# HISTORIC AND DESIGN REVIEW COMMISSION

November 06, 2019

**HDRC CASE NO:** 2019-648  
**ADDRESS:** 115 QUEENS CRESCENT  
**LEGAL DESCRIPTION:** NCB 3087 BLK 3 LOT S IRR 99.22 FT OF 17 0.235 AC  
**ZONING:** MF-33, H  
**CITY COUNCIL DIST.:** 1  
**DISTRICT:** Monte Vista Historic District  
**APPLICANT:** Angela Blake/BLAKE ANGELA LUTHI & TIMOTHY LEE  
**OWNER:** Angela Blake/BLAKE ANGELA LUTHI & TIMOTHY LEE  
**TYPE OF WORK:** Addition, window replacement, exterior repairs  
**APPLICATION RECEIVED:** October 24, 2019  
**60-DAY REVIEW:** December 23, 2019  
**CASE MANAGER:** Huy Pham  
**REQUEST:**

Front of  
Carport

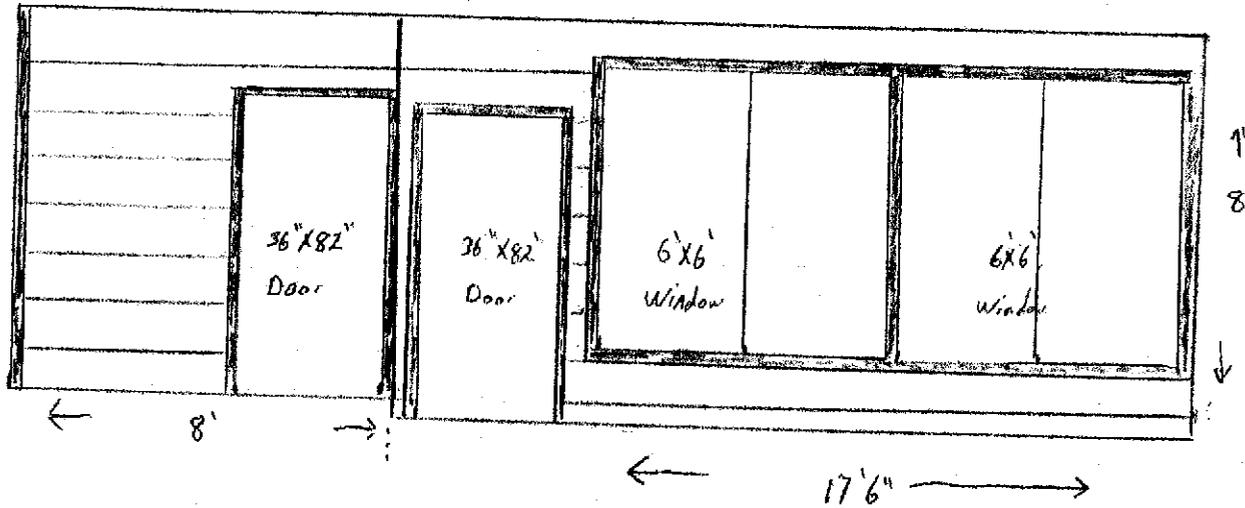
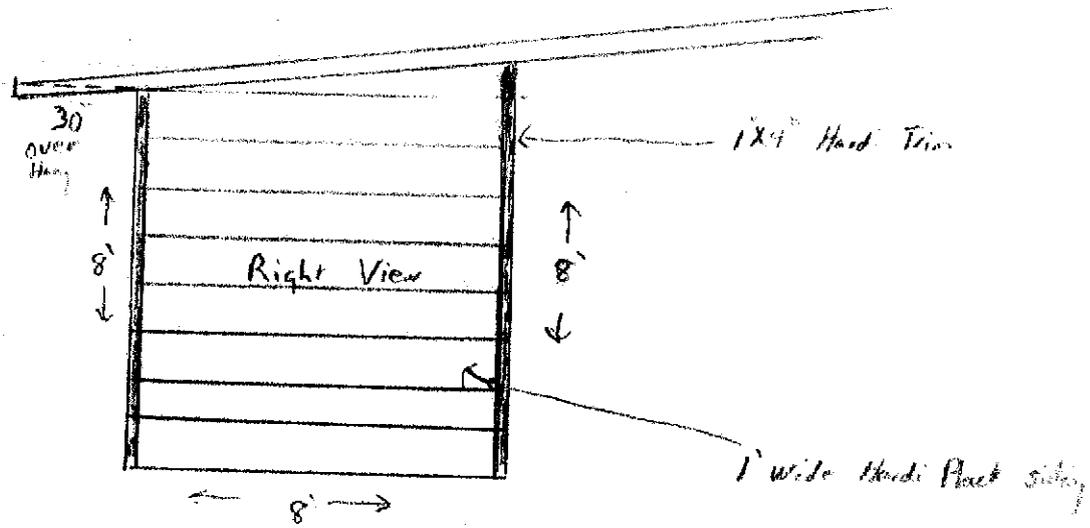
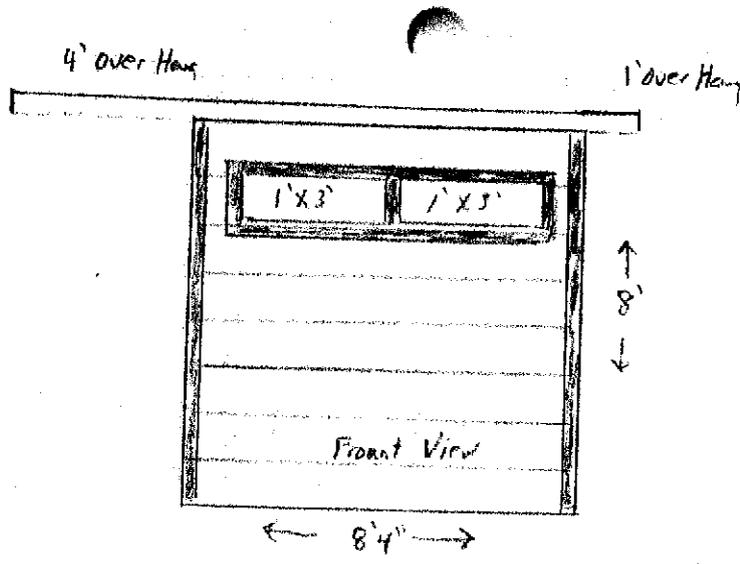
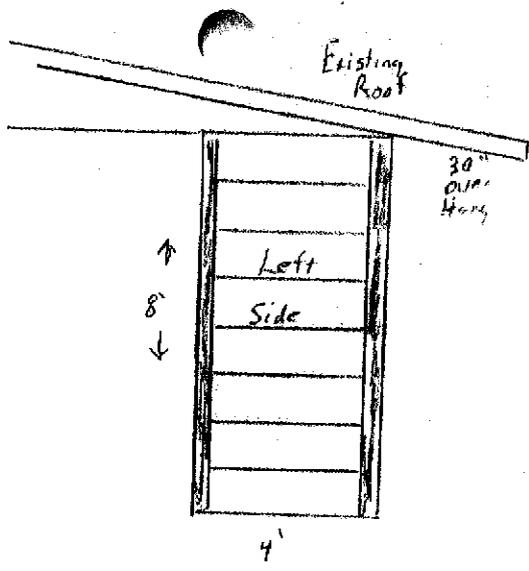
- k. REAR CAPORT ENCLOSURE - That a vertical trim piece is used to distinguish the between the original inset wall and the new addition
- l. WINDOW REPLACEMENT - That the new window should relate to the original metal casement windows with divided lights of the historic structure or be an improvement from the wood sash window; the fixed vinyl window is inconsistent with the Guidelines for Exterior Maintenance and Alterations.

Right Side  
of Existing Room

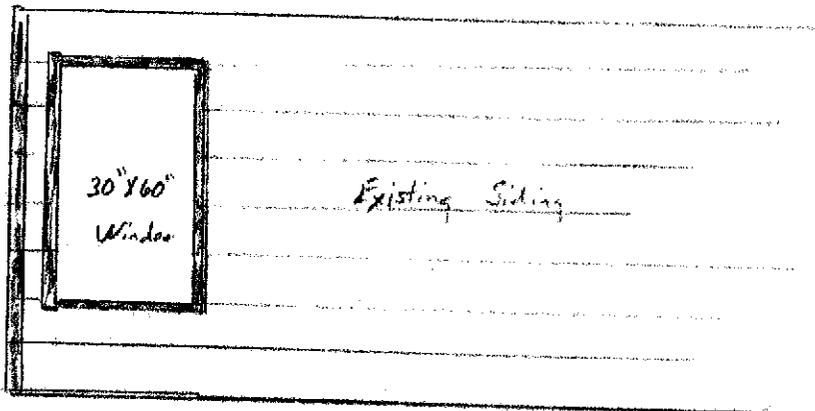
- f. SIDING REPLACEMENT – The applicant has proposed to replace the asbestos siding on the side addition with new wood siding after fenestration modifications. Per the Guidelines for Additions 4.A.ii., applicants should incorporate architectural details that are in keeping with the architectural style of the original structure; details should be simple in design and compliment the character of the original structure. Staff finds the siding on the non-original addition may be replaced if the new siding relates to, but does not have to match, the asbestos siding on the rest of the historic structure in exposure height and lap configuration.

- m. SIDING REPLACEMENT - That the siding on the non-original addition may be replaced if the new siding relates to, but does not have to match, the asbestos siding on the rest of the historic structure in exposure height and lap configuration. Siding specifications shall be submitted to staff prior to approval.
